City of Sandy

Planning Commission Meeting
Meeting Date: Monday, April 27,
2020
Meeting Time: 7:00 PM

| 6.1. | 19-046 MOD/VAR/DEV Sandy Vault Modification | 12 - 160 |

E16-055 GRADING PLAN WEST.dwg 16:40 06/05/2019

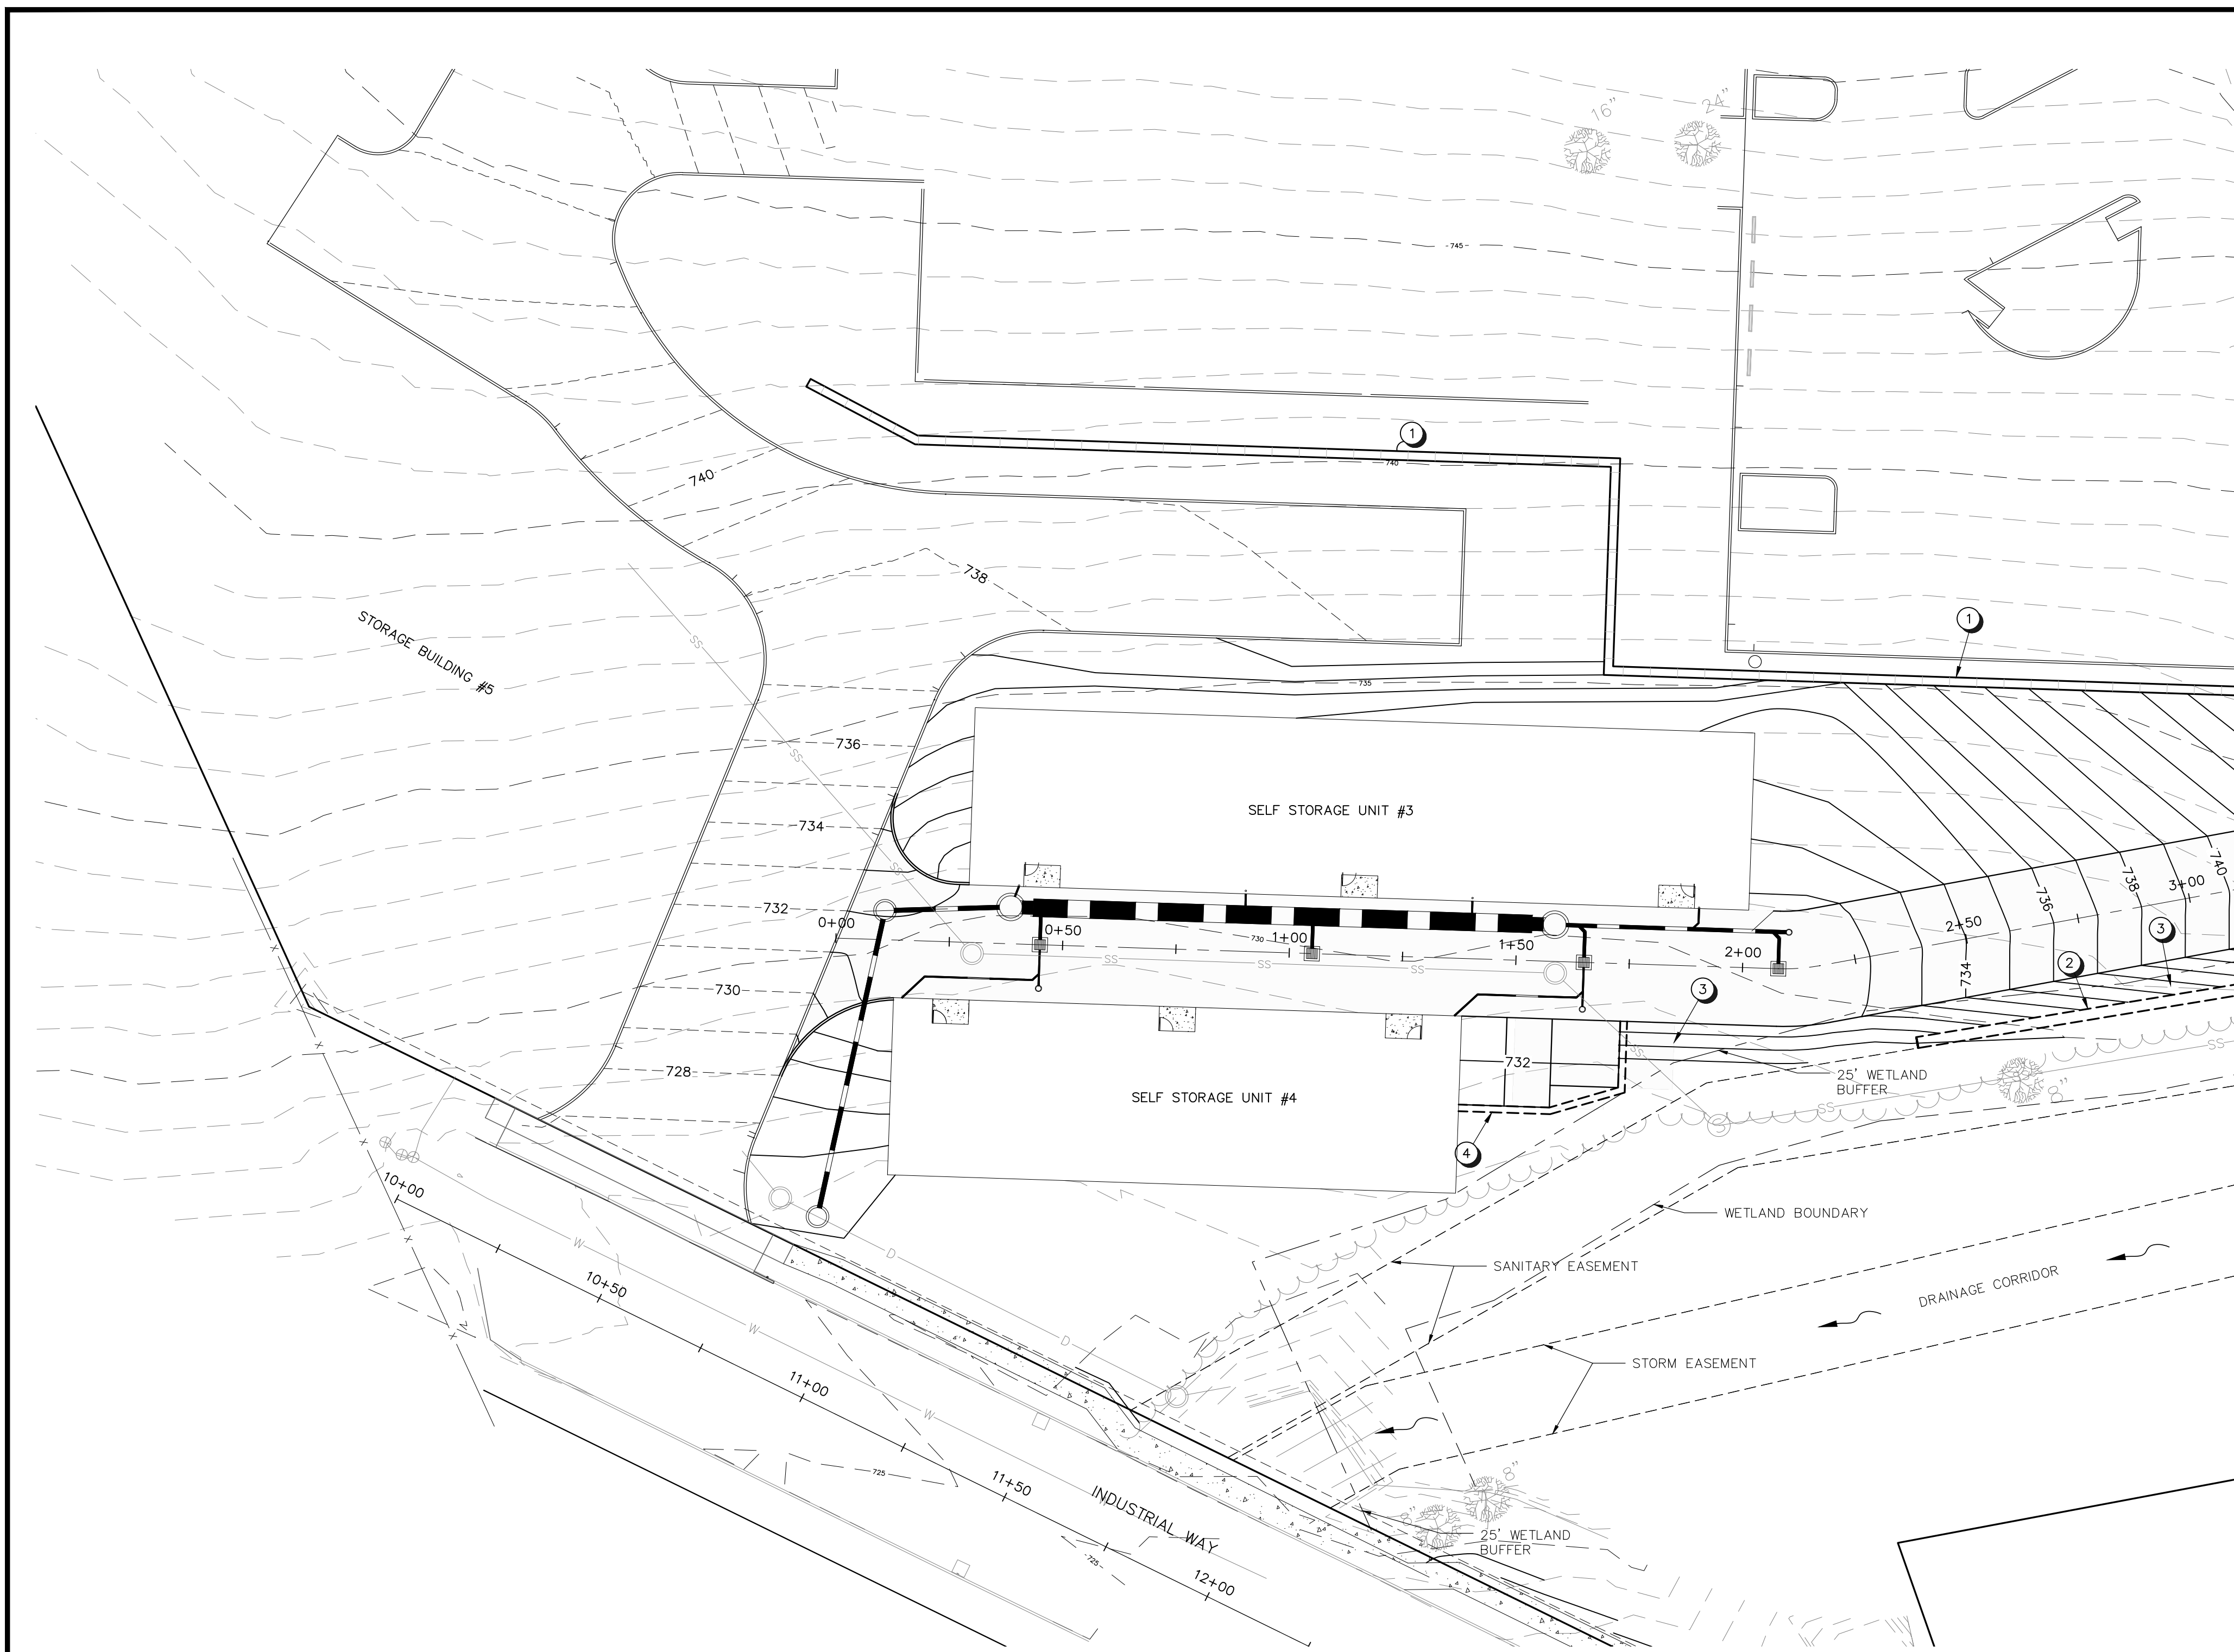
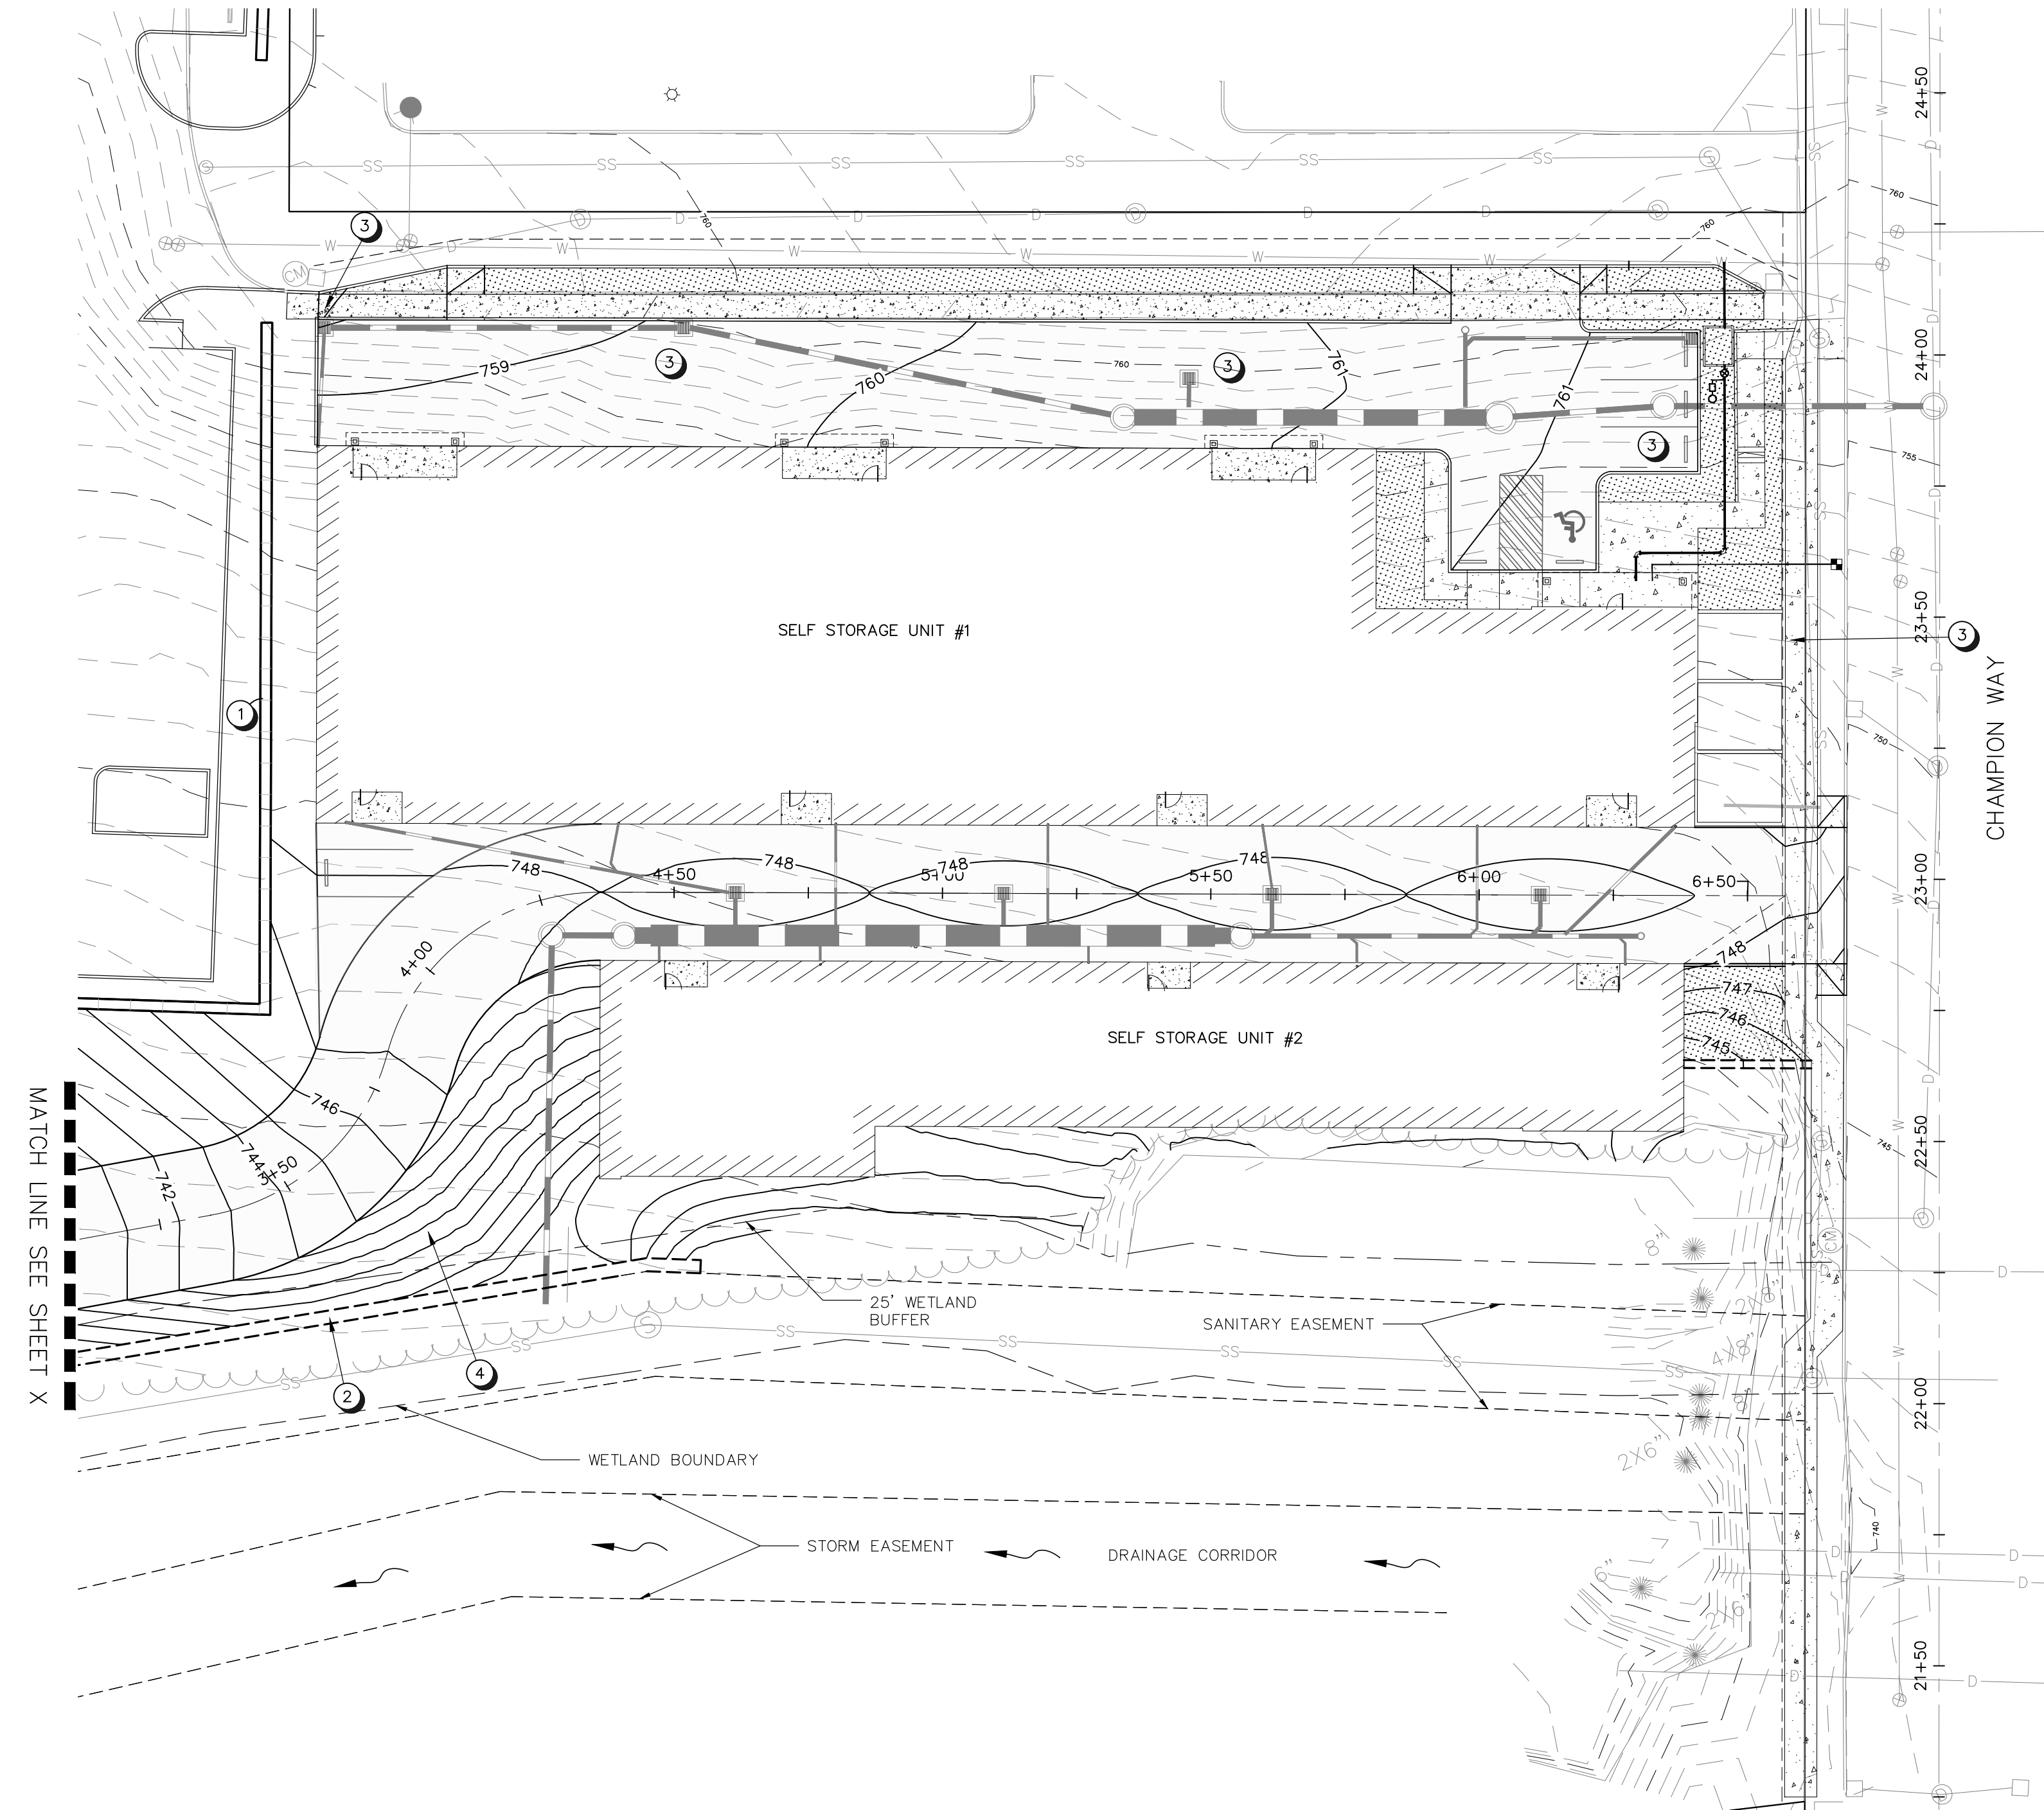
The site has existing topography that slopes away from Highway 26. The submitted Grading Plan (Exhibit C, Sheet 6) shows the location of the proposed retaining wall along Champion Way as well as proposed re-grading of the site. The applicant's deviation, adjustment, and variance narrative (Exhibit B) states: "Since it is constructed perpendicular to the slope of the land, the wall will step down and thus the maximum height of 8'-6" (Approx.) will only occur at the end of each step and the average height of each segment will be lower." The Grading Plan with retaining wall details (Exhibit C, Sheet 6) includes an elevation of the proposed terraced wall and confirms that a majority of the wall will be less than 6 feet in height, with only one terraced segment exceeding 6 feet in height. Thus, staff believes the wall design does not violate the intent and purpose of the retaining wall height requirements nor will it be materially detrimental to the public welfare. Criterion A is met. Per the narrative, "The area supported by the retaining walls will be terraced and landscaped in an attractive manner as shown on the Landscape Plan. Additionally, the wall itself will be constructed of an attractive, architectural material keyed to the building facades."
